17 June 2022
Our Ref: 21007D.6NB (S4.55(2))

**RE: SECTION 4.55(2) APPLICATION TO MODIFY
DEVELOPMENT CONSENT SSD-11920082
HASTINGS SECONDARY COLLEGE – PORT MACQUARIE CAMPUS
16 OWEN STREET, PORT MAQUARIE**

Figure 3 Proposed Owen Street, CAPA/ Entry Streetscape

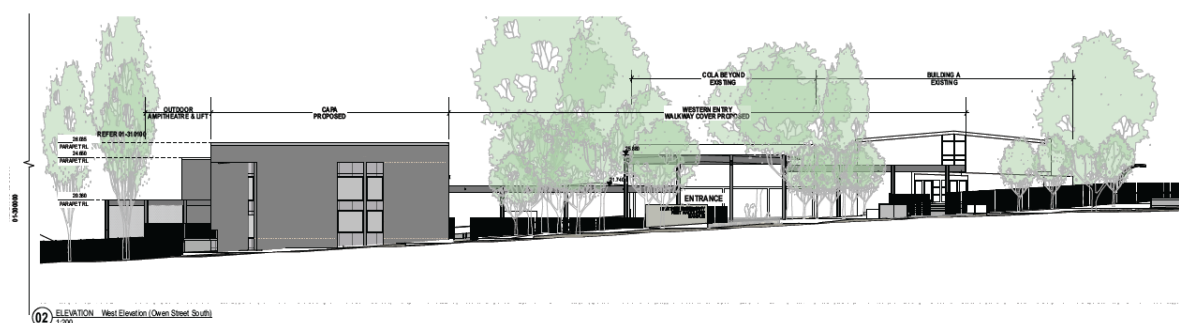
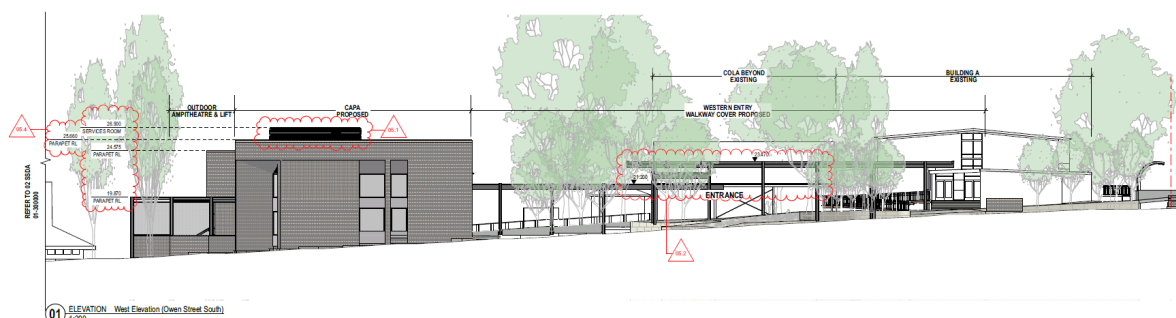
The proposed external alterations will alter the Owen Street streetscape through the addition of mechanical plant, external stairs and a reconfiguration of the entrance to Building A and the associated undercover canopy area. Overall, the modifications have minimal visual or height impact to the streetscape when compared to the approved design. The approved height of the development is 13.88m. The height of the CAPA with the mechanical plant is 11.96m. **Figures 2 and 3** are comparisons of the Owen Street elevation with **Figure 2** being the approved elevation and **Figure 3** incorporating the proposed modifications.

Figure 5 Modified CAPA/ Building A Entry/ Landscape

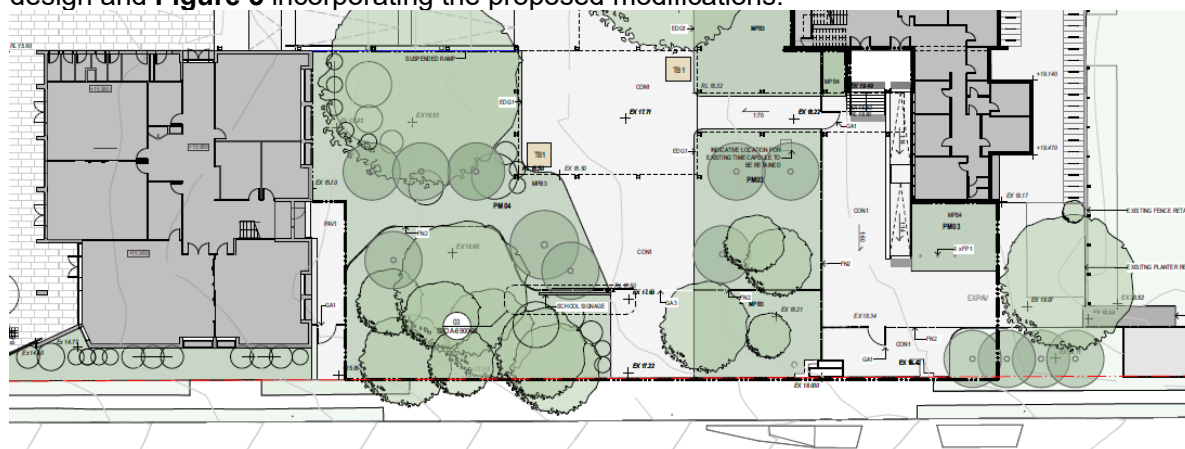
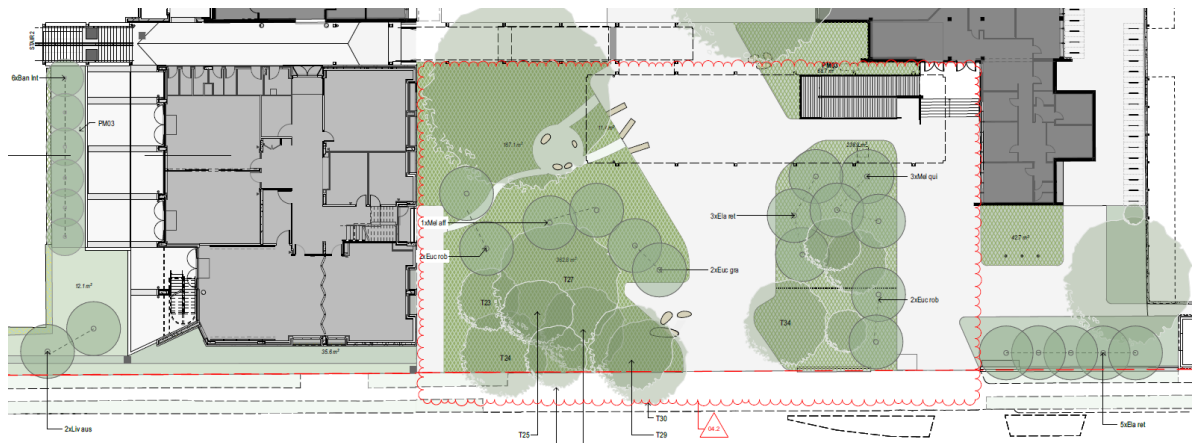
Figures 4 and 5 are comparisons of the entry landscaping, with **Figure 4** being the approved design and **Figure 5** incorporating the proposed modifications.

Figure 7 Proposed Landscaping north of Building B

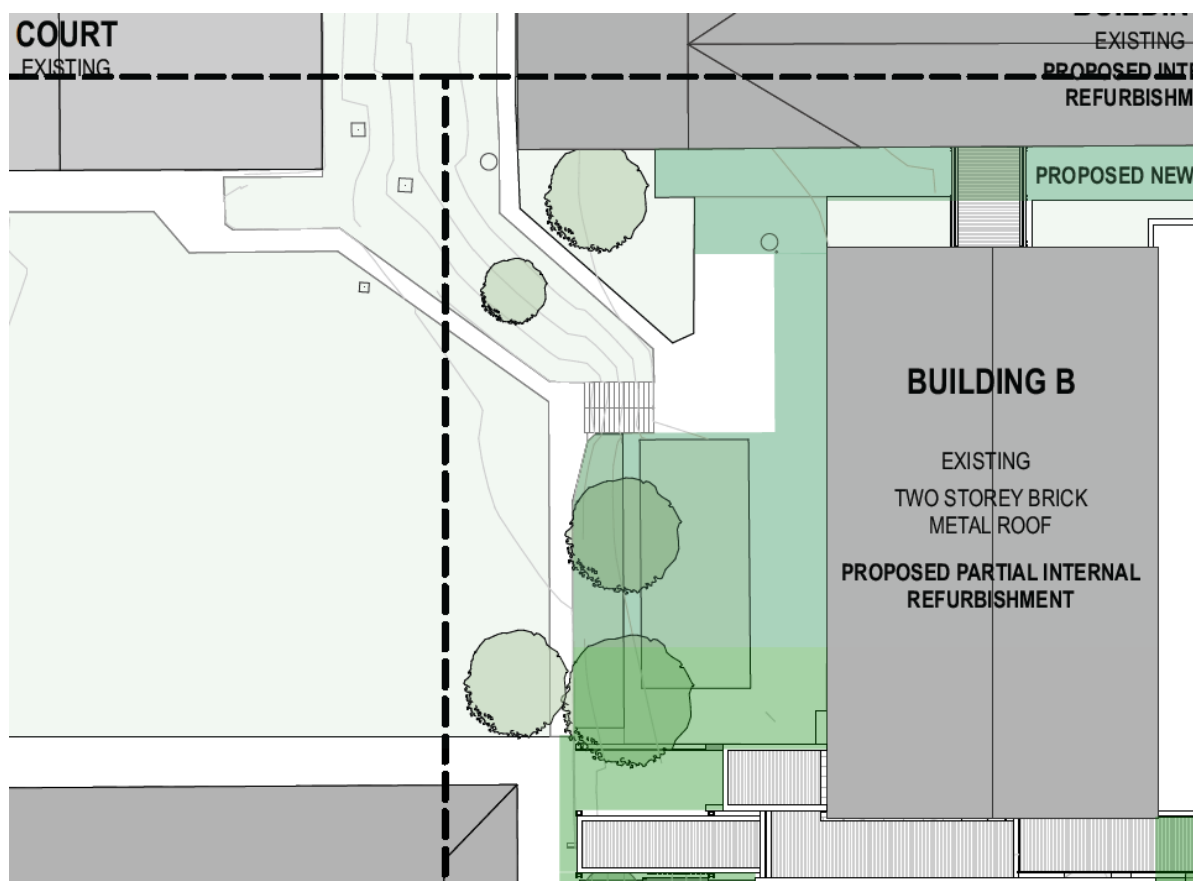
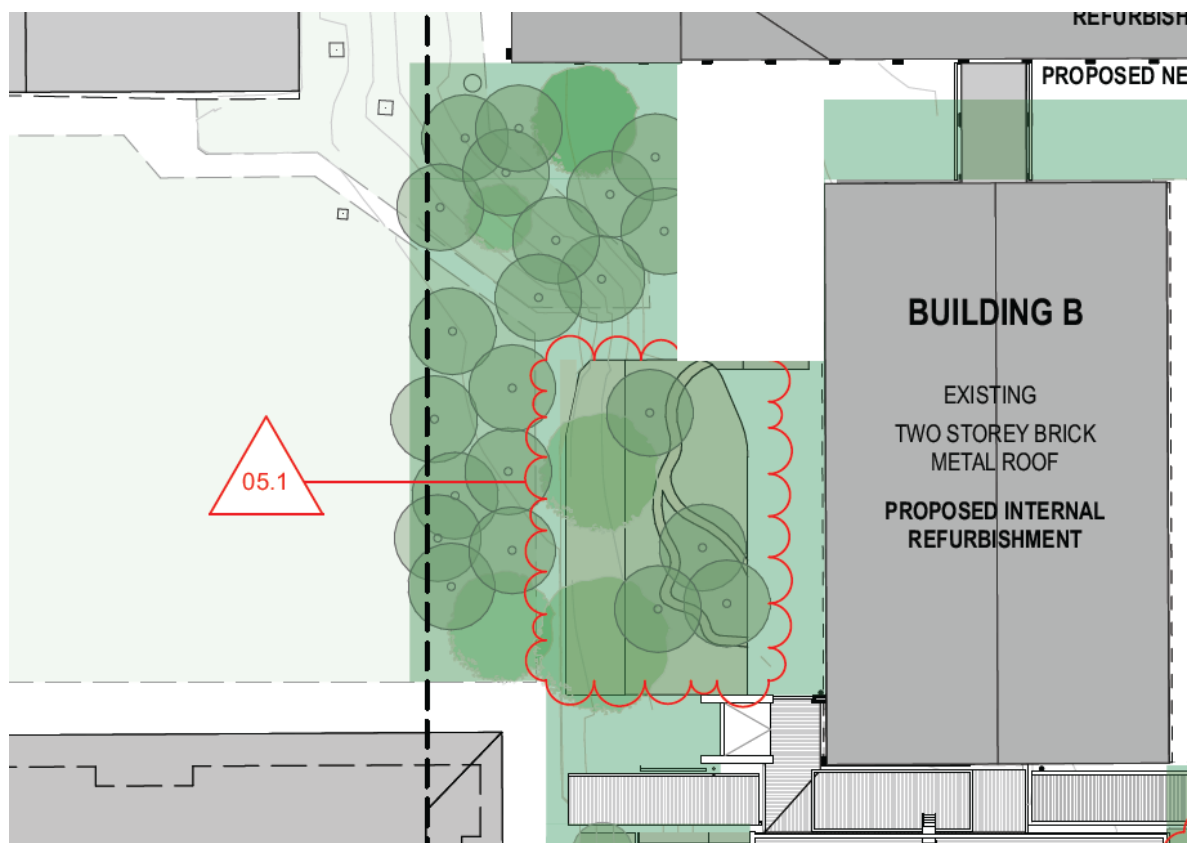
Figures 6 and 7 are comparisons of the landscaping to the north of building B, with **Figure 6** being the approved design and **Figure 7** incorporating the proposed modifications.
